RS-22-084

Braidwood Station, Units 1 and 2
Renewed Facility Operating License Nos. NPF-72 and NPF-77
NRC Docket Nos. STN 50-456 and STN 50-457

Subject: Response to Request for Additional Information - Proposed Alternative for Examinations of Examination Categories B-B, B-D, and C-A Steam Generator Pressure Retaining Welds and Full Penetration Welded Nozzles

Response to Request for Additional Information

Figure RAI 6-1: Applied K vs. Fracture Toughness as a Function of Temperature for Case ID SGPNV-P1A-(N)
(Using Braidwood Unit 2 and Byron Unit 2 Plant-Specific Upper Bound SG Material RT_{NDT} Value of 60°F)

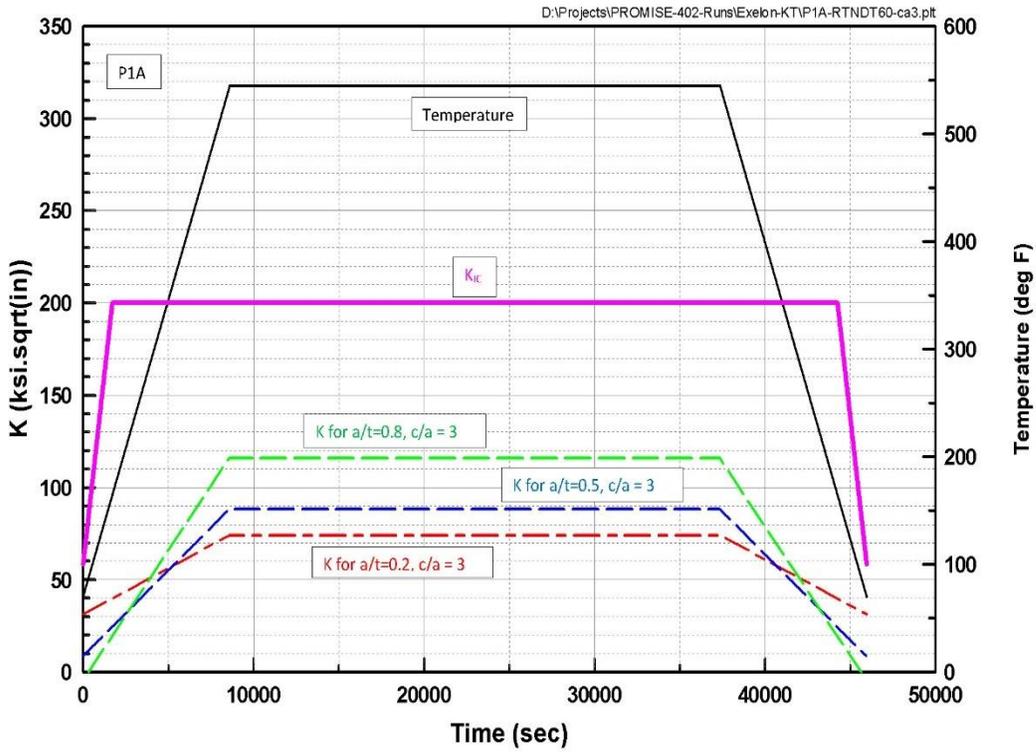
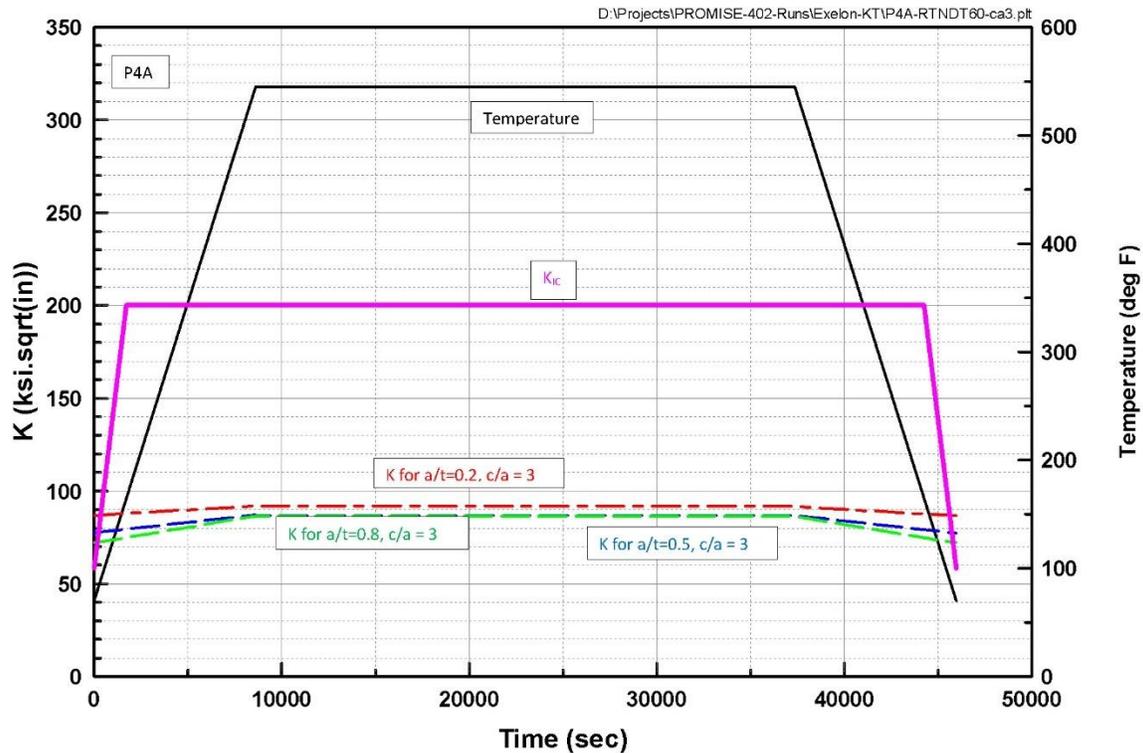
For the B2.40 and B3.130 welds of the subject units requested in the submittal, the tables in Appendix A to the submittal that show the transient cycles for each of the units also show the lowest temperatures for the Heatup/Cooldown transient for each unit: 120°F for Braidwood and Byron (Tables A3, A4, A7, and A8), 70°F for Calvert Cliffs (Tables A12 and A13), and 100°F for Ginna (Tables A16 and A17). Section 8.2.2.5 of EPRI report 15906 states that the minimum temperature (200°F) during this transient corresponds to Figure 7-22 of EPRI report 15906; therefore, a fracture toughness (K_{IC}) set at the upper shelf value of the ASME Code K_{IC} curve, 200 ksi \sqrt{in} , may be used. The NRC staff noted that Figure 7-22 of EPRI report 15906 is at the

end of heatup (as noted in the figure). During the ramp periods at the beginning and end of the Heatup/Cooldown transient, the temperatures at the subject B2.40 and B3.130 welds of the subject units could be lower than 200°F as indicated in the above tables, and thus, K_{IC} could be lower than 200 ksi√in. A similar issue was addressed for Millstone 2 in letter dated March 19, 2021 (ADAMS Accession No. ML21081A136) through plots that compare the K_{IC} history for the Heatup/Cooldown transient, which were determined based on a plant-specific RT_{NDT} value of 0°F for the Millstone 2 SG, with the corresponding applied stress intensity factor history (Figures RAI-4-1 and RAI-4-2 in the March 19, 2020 letter). The comparison showed that the applied stress intensity factor during anytime of the Heatup/Cooldown transient did not exceed the lowest K_{IC} plant-specific value for Millstone 2 and was accepted by the NRC staff in the safety evaluation dated July 16, 2021 (ADAMS Accession No. ML21167A355).

Show that the applied stress intensity factor at the B2.40 and B3.130 SG welds of the subject units during anytime of the Heatup/Cooldown transient does not exceed the lowest plant-specific K_{IC} value for each subject unit that occur at the beginning and end of the Heatup/Cooldown transient.

For the original SG materials at Braidwood Unit 2 and Byron Unit 2, the maximum RT_{NDT} value is guaranteed to be no greater than 60°F. Although the actual values are expected to be lower, records were not readily available to determine the exact value and therefore the maximum value of 60°F is assumed. For the original SG material at Calvert Cliffs Units 1 and 2, the maximum RT_{NDT} is 40°F. It should be noted that the original SGs at Calvert Cliffs Units 1 and 2 do not contain the critical Case ID SGPTH-4A in the Reference [7] EPRI Report which is associated with the tubesheet-to-head weld (Item No. B2.40) on the primary side. The Item Numbers associated with the original SGs at Calvert Cliffs Units 1 and 2 are C1.10 and C1.20. Tables 8-3 and 8-13 through 8-16 of the Reference [7] EPRI Report indicate that there are significant margins in the analysis for these Item Nos with respect to fracture toughness. As such, the SGs at Braidwood Unit 2 and Byron Unit 2 are bounding since they contain the critical Case ID and have the highest RT_{NDT} value. An evaluation similar to that performed in response to RAI 4 for Millstone Unit 2 in ADAMS Accession No. ML21081A136 [10] was repeated using the limiting RT_{NDT} value of 60°F to address the original SG materials at Braidwood Unit 2 and Byron Unit 2. The two Case IDs considered for Millstone Unit 2 (SGPNV-P1A(N) and SGPTH-4A) were also evaluated in this case. The results are shown in Figures RAI 6-1 and RAI 6-2 for Case IDs SGPNV-P1A(N) and SGPTH-P4A, respectively.

As can be seen in Figure RAI 6-1, for Case ID SGPNV-P1A(N), the applied stress intensity factor (K) is below the fracture toughness throughout the transient; however, for Case ID SGPTH-4A, the applied K is higher than the allowable fracture toughness in the beginning part of the heatup transient and at the end of the cooldown transient, with the allowable fracture toughness between 72 $ksi\sqrt{in}$ to 86 $ksi\sqrt{in}$. Figure 8-6 of the Reference [7] EPRI Report shows that the 80% and 50% through-wall flaws evaluated in Figure RAI 6-2 would have been detected by the POD curve in the PFM evaluation, resulting in the allowable fracture toughness of 86 $ksi\sqrt{in}$ being the most realistic case. Therefore, conservative lower bound fracture toughness of 80 $ksi\sqrt{in}$ at the beginning of heatup and end of cooldown for the Case ID SGPTH-P4A is used to perform a sensitivity study on fracture toughness. This is similar to the sensitivity study performed in Table 8-14 of the Reference [7] EPRI Report, where it was demonstrated that fracture toughness as low as 80 $ksi\sqrt{in}$ would meet the acceptance criteria.

The results of the DFM evaluation presented in Table 8-3 of the Reference [7] EPRI Report showed that for Case ID SGPTH-4A, the maximum K obtained in the transient analysis is 77.8 $ksi\sqrt{in}$, which further justifies the use of an allowable fracture toughness 80 $ksi\sqrt{in}$. However, the sensitivity study presented in Table 8-14 of the Reference [7] EPRI Report was performed for a PSI/ISI scenario of (PSI +20+40+60). It was therefore repeated using the plant-specific PSI/ISI scenario for Braidwood Unit 2 and Byron Unit 2 (PSI+10+20+30+66) representing the deferral period of 35.2 years for Braidwood Unit 2 from Table 1 of the proposed alternative [1]. The
